Meeting Date: June 21, 2022

Hearing Body: Planning and Zoning Commission

Project Summary: **Zone Change to permit construction of a parking lot and conversion of existing single-family house into multi-family units for employee housing and an office**

PZ21-00016 (ZC) Planning Comments

1 Preliminary Parking Signage Plan

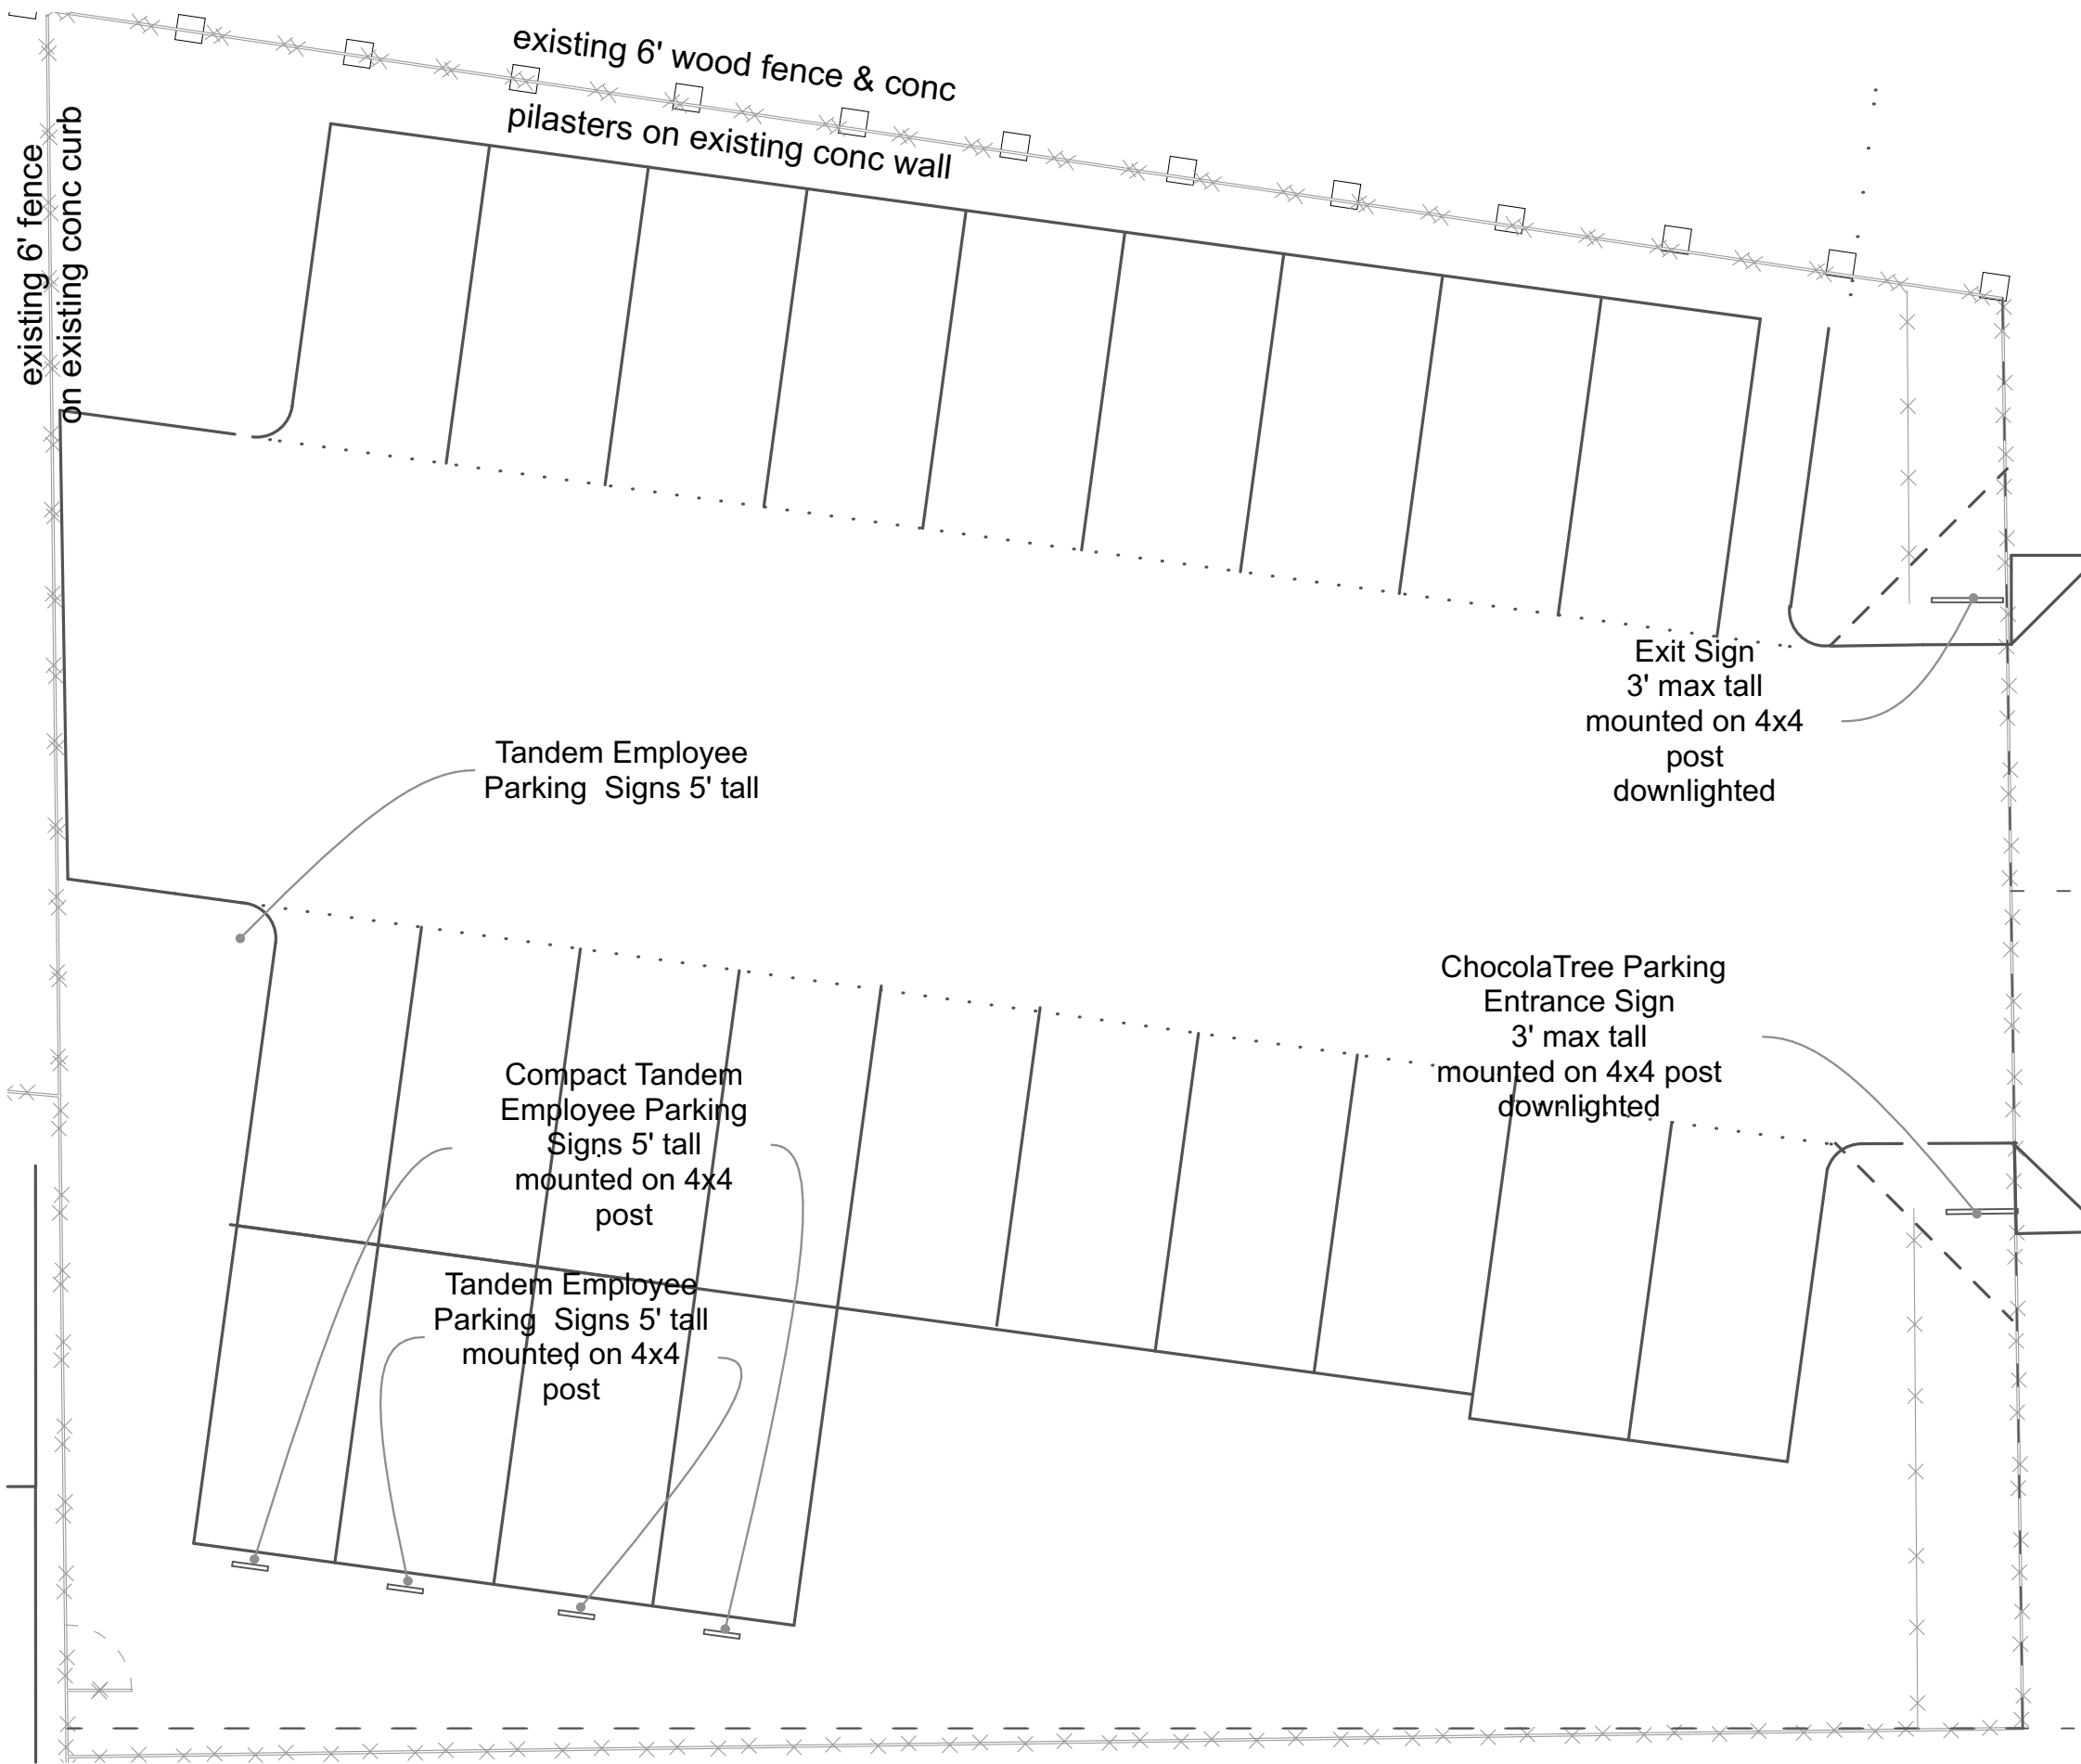
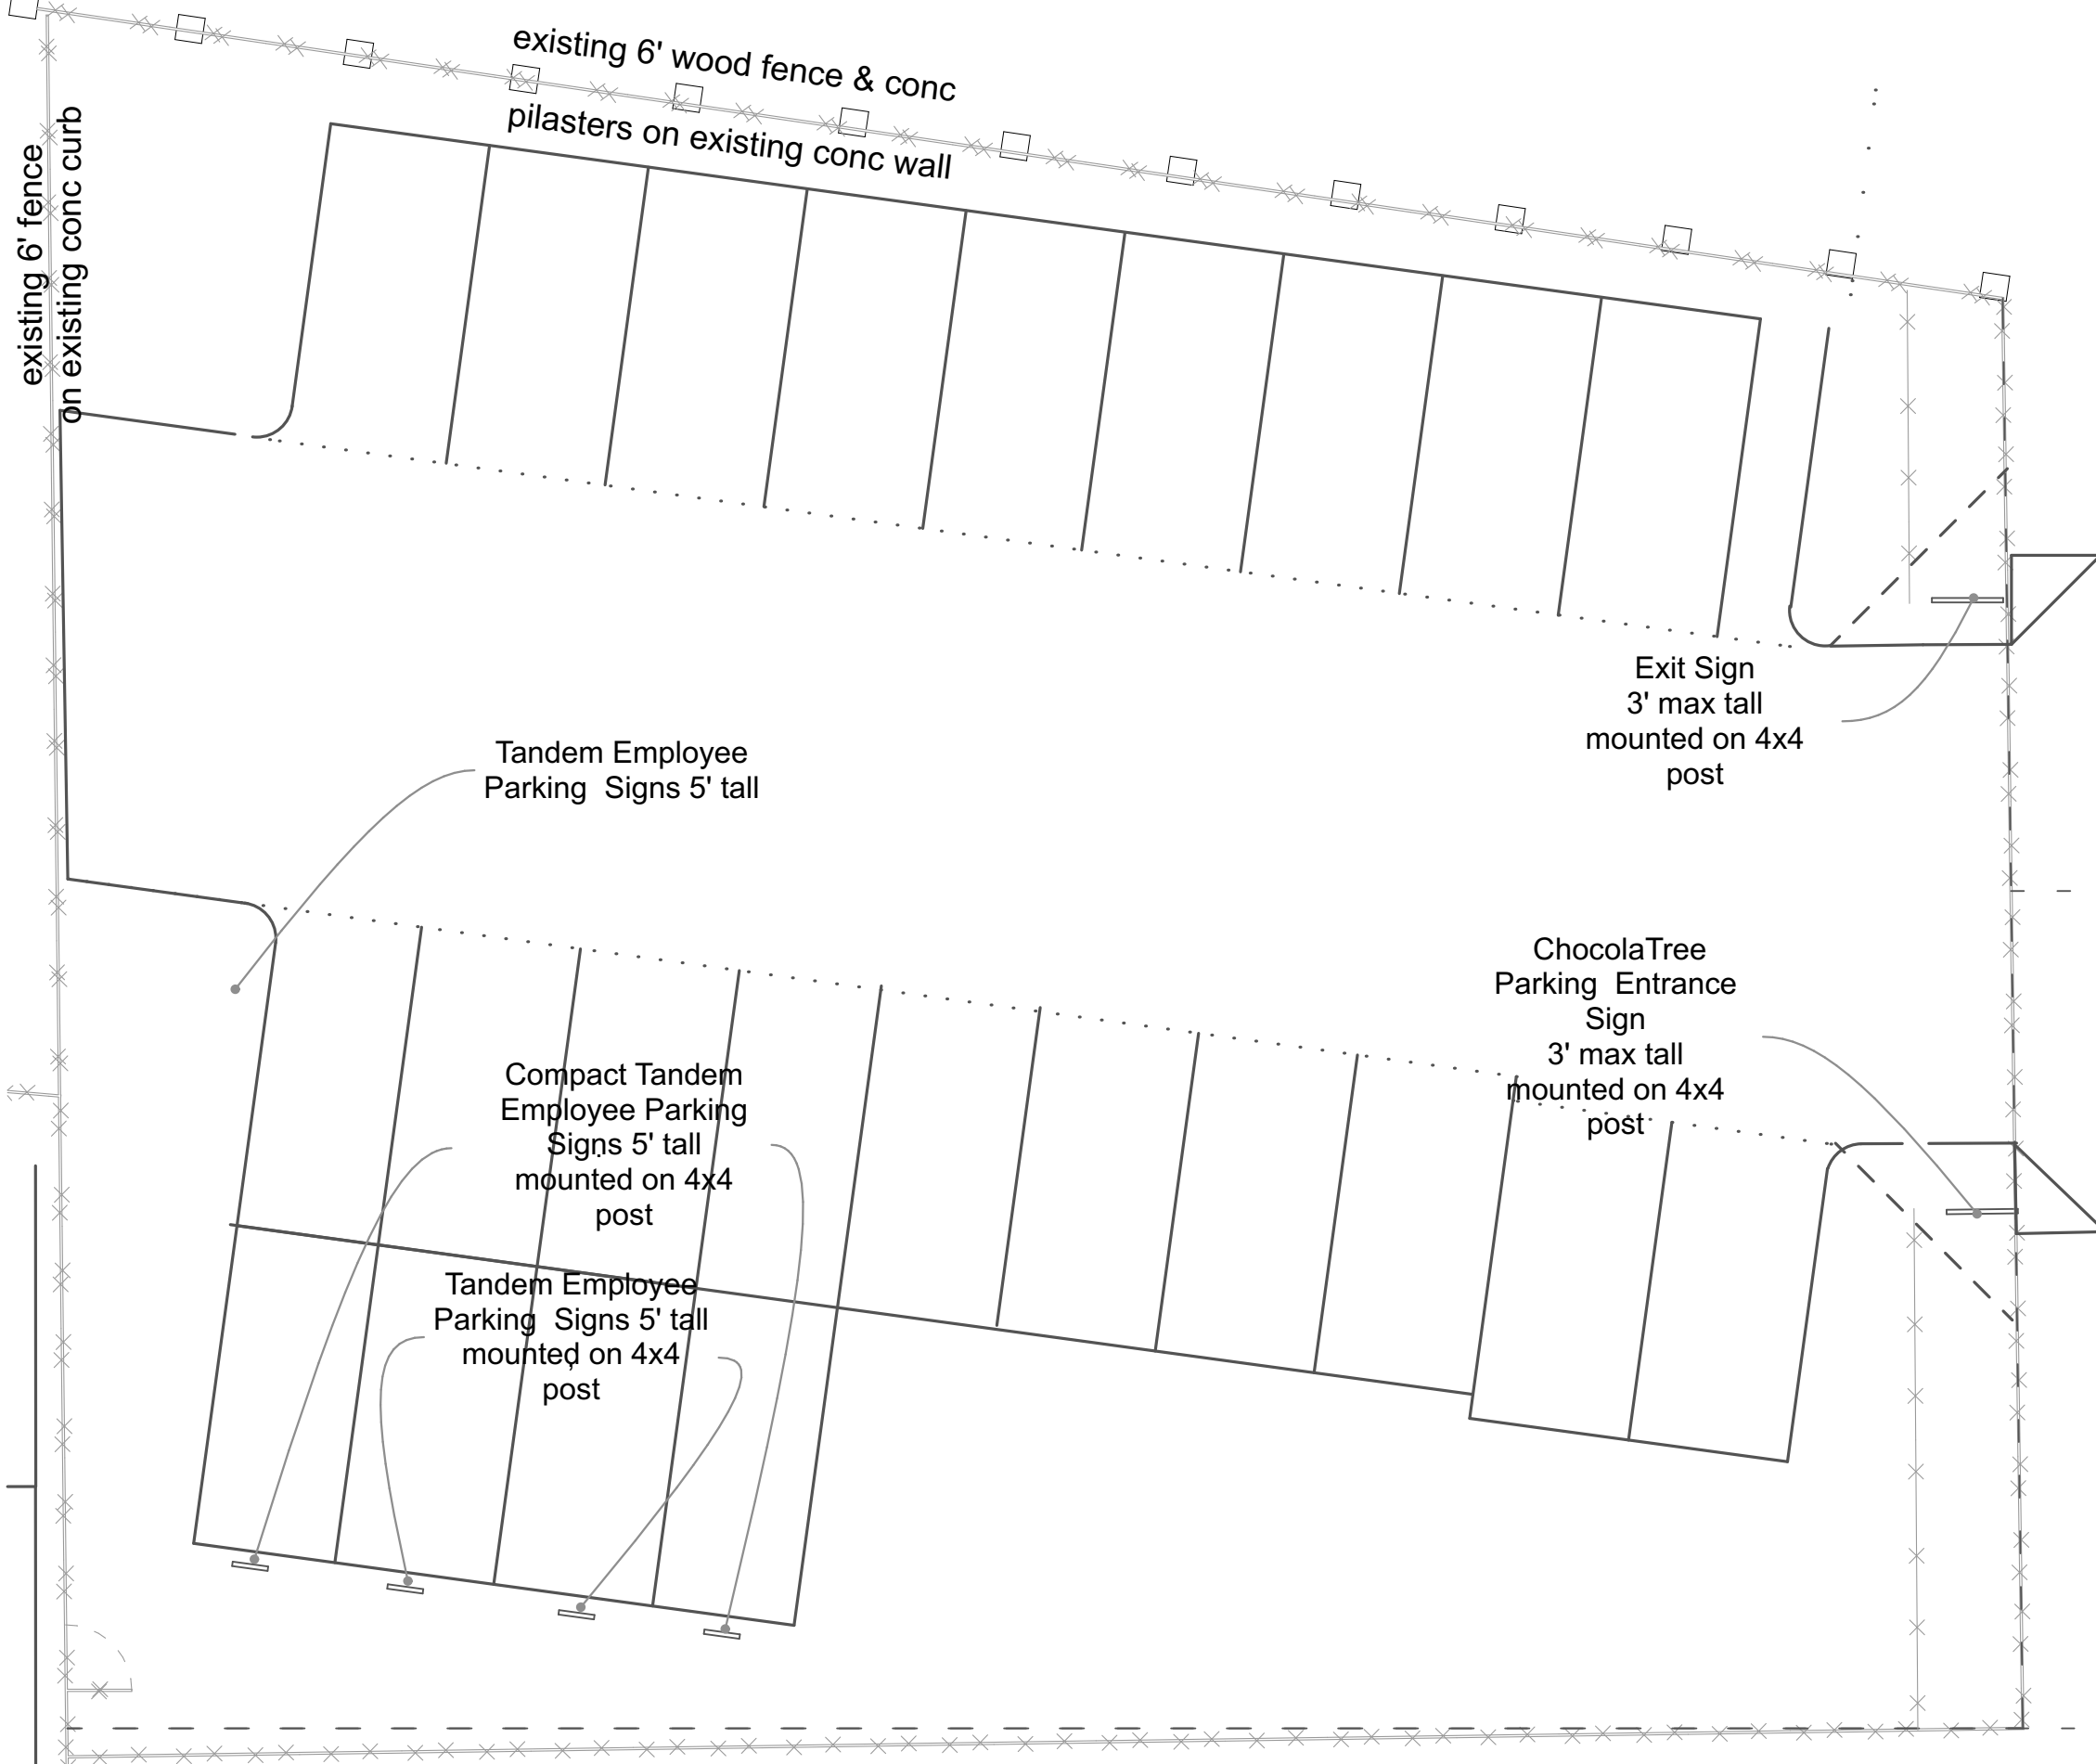
- i) <https://www.sedonaaz.gov/home/showpublisheddocument/44952/637732617633670000>
11. Signs – See LDC Article 6
- a) Provide a color sample for the sign background color.

- b) Provide mounting details and overall height for signs.
 - c) Consider switching the location of the proposed sign, with the entrance sign on the northern side of the driveway and the exit sign on the southern side of the driveway, so it is easily seen by vehicles exiting the site.

3. Compact spaces must be signed and mounted 5' above grade.
4. Move the new ADA space closest to the driveway. Provide signage per the city's Design, Review, Engineering and Administrative Manual section 3.4.C.(1)b.

11. See attached named “111a.b.c. Preliminary Parking Signage Plan.” The color of sign is white background and dark brown letters, same as ChocolaTree sign but reverse.

3. Compact spaces must be signed and mounted 5' above grade. See "11a.b.c. Preliminary Parking Signage Plan."
4. The new ADA space to be at existing ChocolaTree parking lot adjacent to existing ADA space shown on drawing "4a current chocolatree parking calculations"
